Addendum #2

VA Project No.: 553-21-100

Project: Renovate A2 South for Cancer Clinic
John D. Dingell VA Medical Center
Detroit, Michigan

Date: May 1, 2026

ENLARGED MECHANICAL ROOM A2032 HVAC PLAN
MH102/ 1/4" = 1'-0"

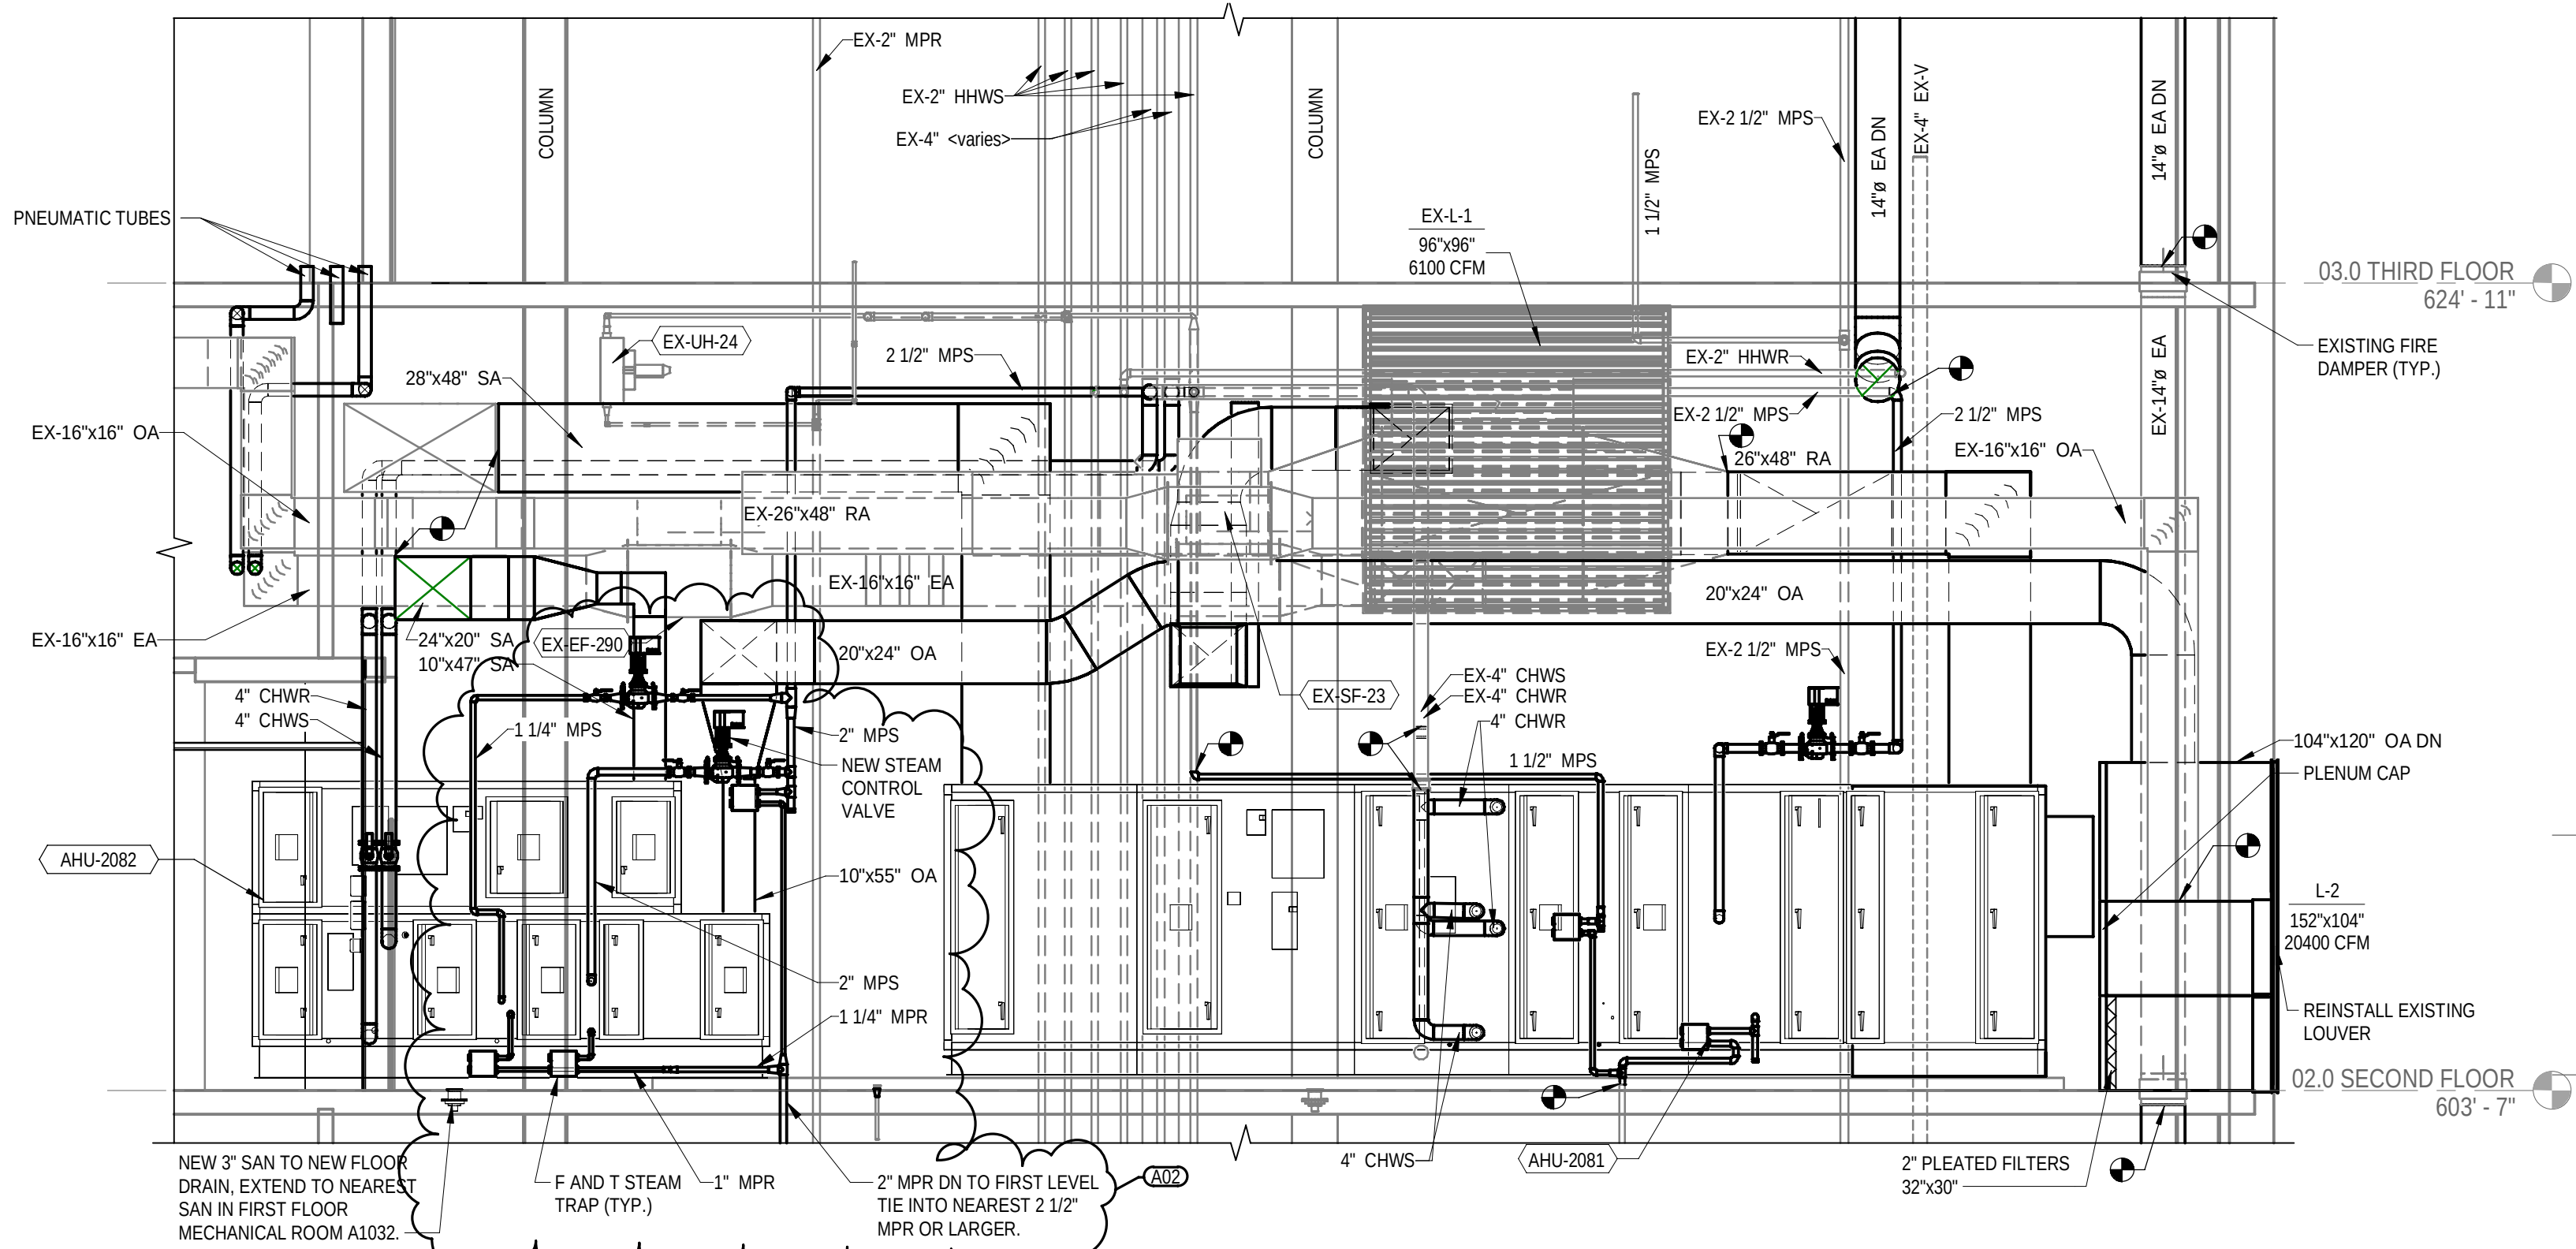
- A2.17 Refer to Sheet M-402 (reissued):
Revise AHU-2082, the MPS (medium pressure steam) and MPR pipe routings to/from the steam humidifier and steam heating coil (HC) on "ENLARGED MECHANICAL ROOM A2032 PIPING PLAN" and "SECTION - MECHANICAL ROOM A2032".

1 AIR HANDLING UNIT AHU-2082 DETAIL
NOT TO SCALE

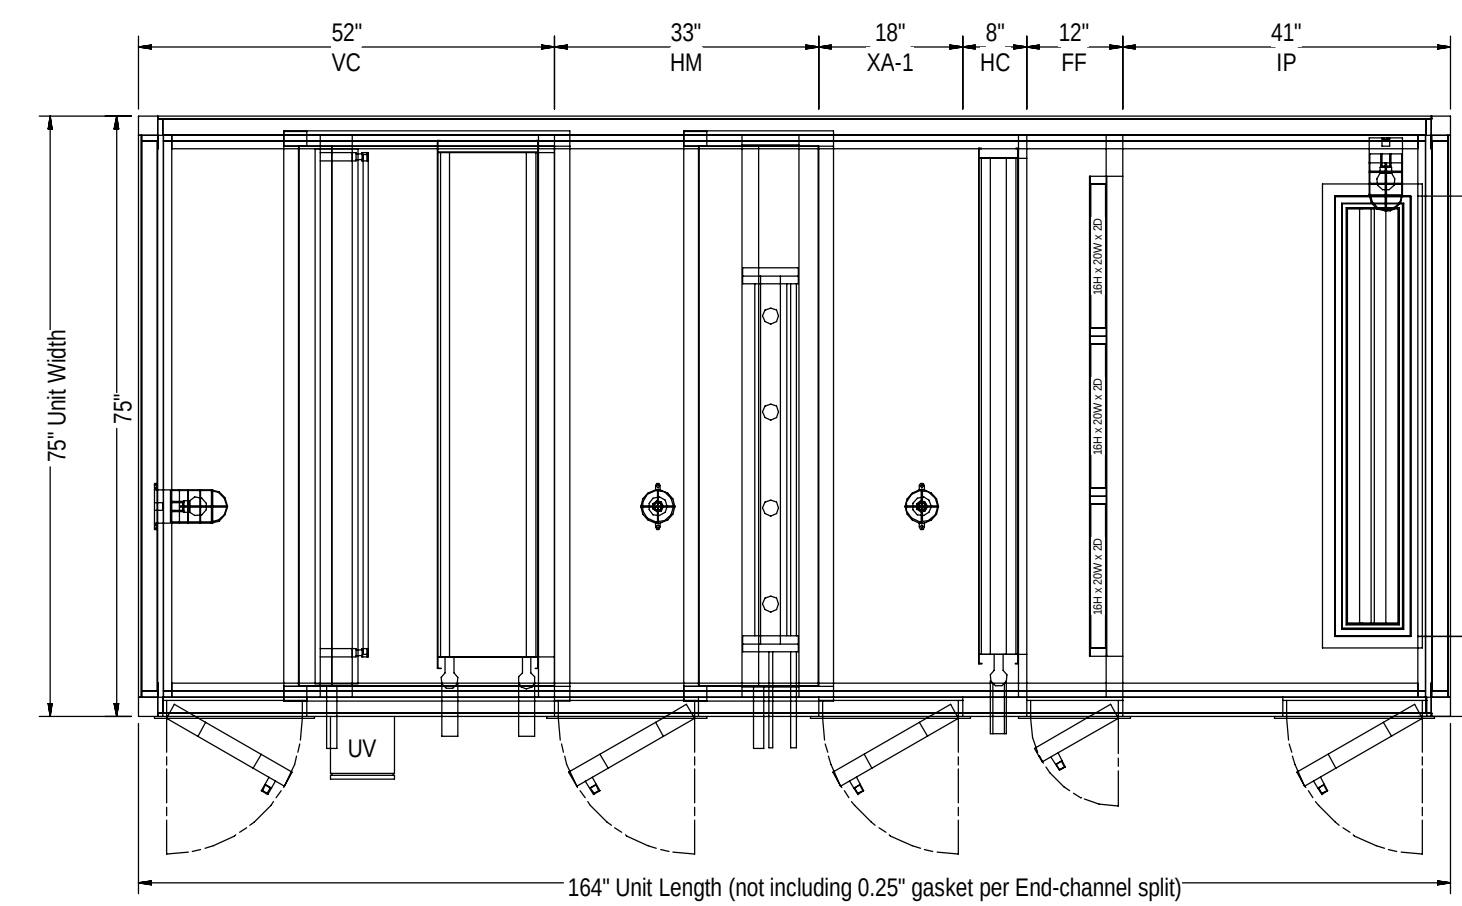
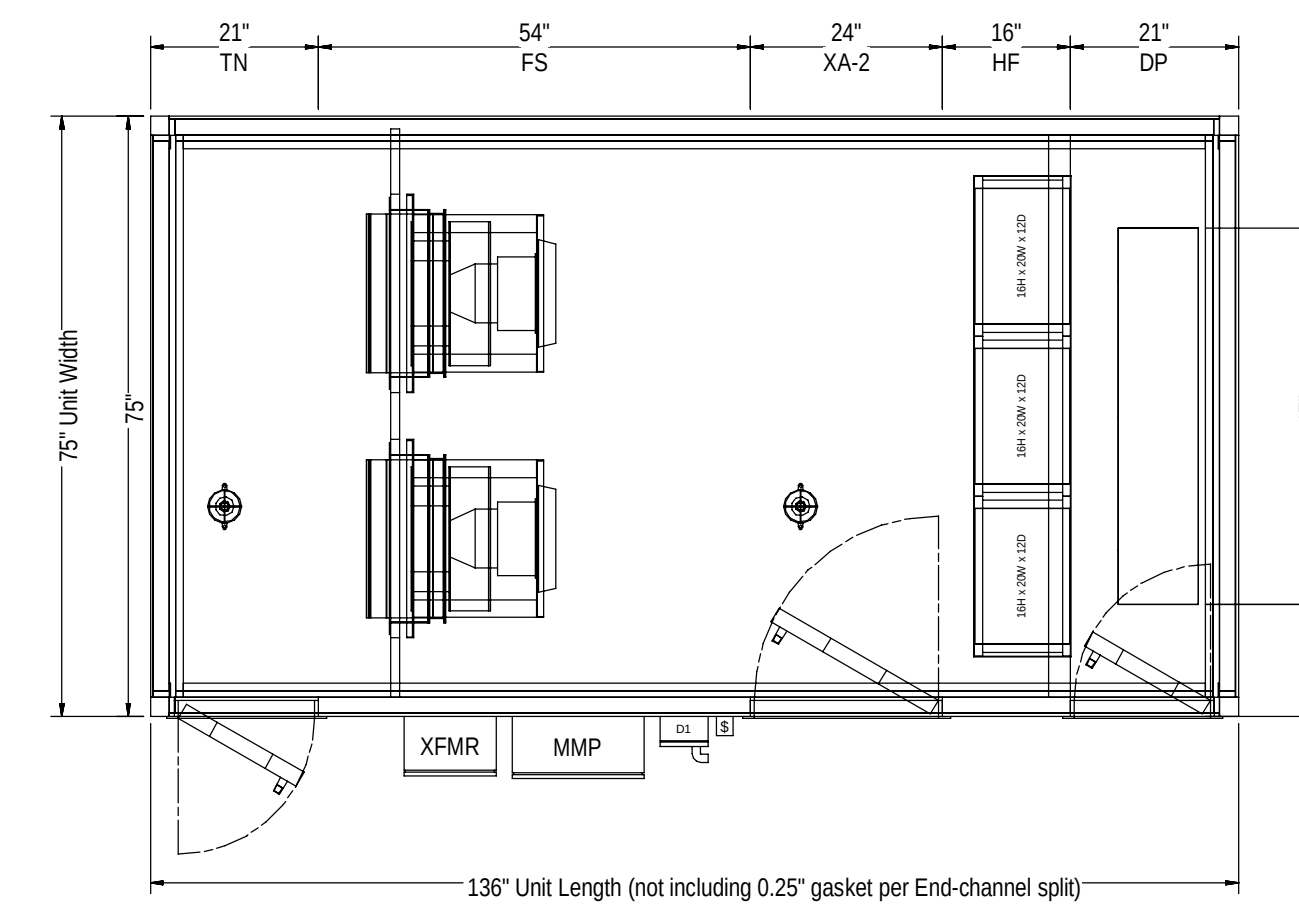
- A2.18 Refer to Sheet M-503 (reissued):
Revise AHU-2082 plan and HC (heating coil) and HM (Humidifier) have been illustrated more clearly; see “AIR HANDLING UNIT AHU-2082 DETAIL”.

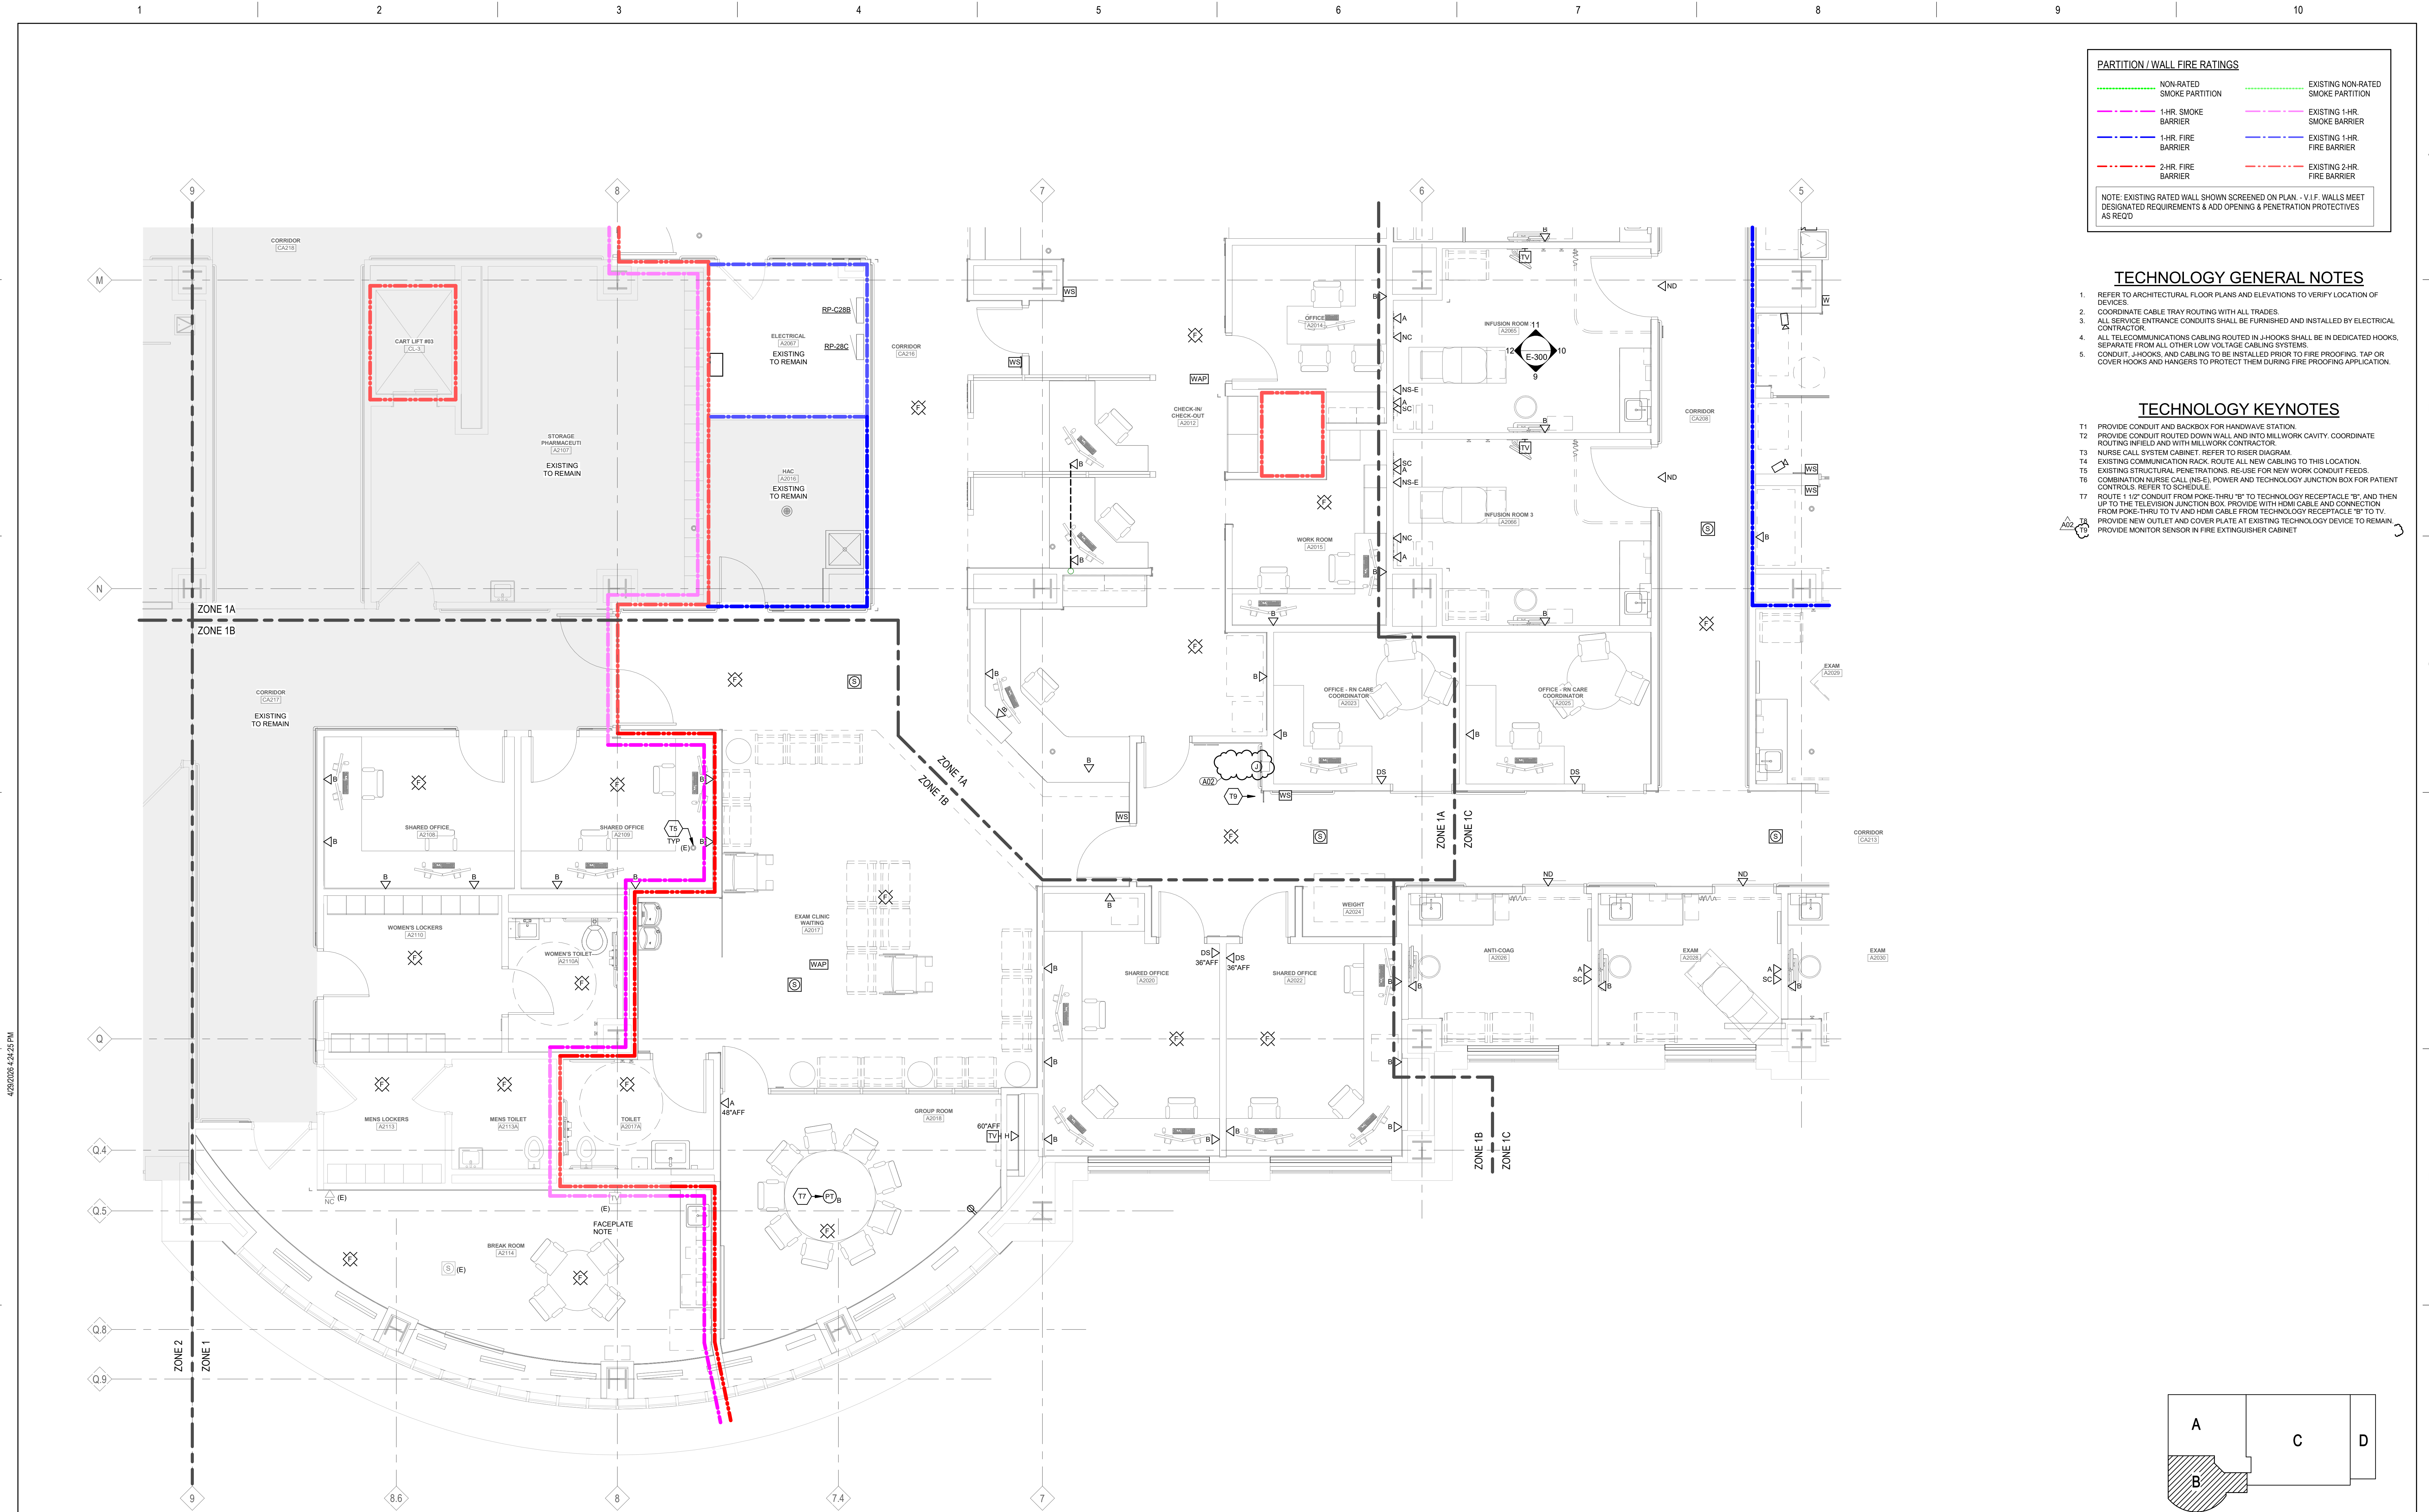
- A2.21 Refer to Sheets ET102.1B, ET102.1C, and ET102.1D (reissued):
Provide fire extinguisher cabinet monitor at locations indicated on plan and call out with new keyed note T9.
